Form 3160-5
(June 1990)UNITED STATES
DEPARTMENT OF THE INTERIOR
BUREAU OF LAND MANAGEMENTFORM APPROVED
Budget Bureau No. 1004-0135
Expires: March 31, 1993**SUNDRY NOTICES AND REPORTS ON WELLS**Do not use this form for proposals to drill or to deepen or reentry to a different reservoir.
Use "APPLICATION FOR PERMIT—" for such proposals**SUBMIT IN TRIPLICATE**

Chaco Limited #1

PLUG AND ABANDON PROCEDURE

CONDITIONS OF APPROVAL

MERRION OIL AND GAS CORP.
WELLBORE SCHEMATIC

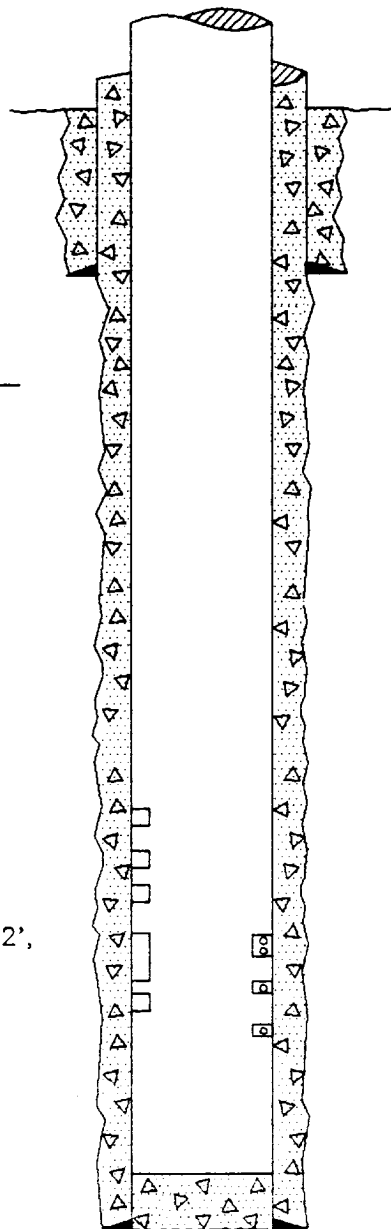
Establish a rate with water before cementing
